SERVICE REQUEST

Request Number: **18181**
Request Type: **Resid Pool Approval**
Associated WO Number:
Date Initiated: 3/17/2011 3:08:39 PM
Submitted To: WALKER, PHILO

Problem Address: **16125 LANGSTON DRIVE, CHARLOTTE, 28278**

APPLICATION FOR RESIDENTIAL POOL CONSTRUCTION

PLOT OF SYSTEM

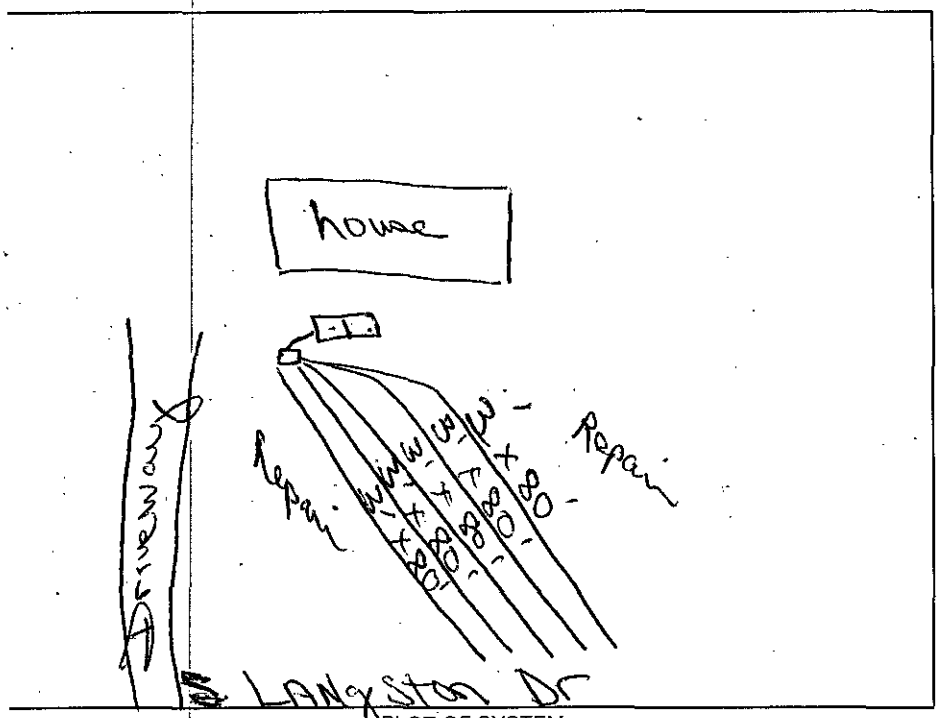
Comments: Install 5 Trenches 3' x 80' x 12" Rock
Run lines on Contour.
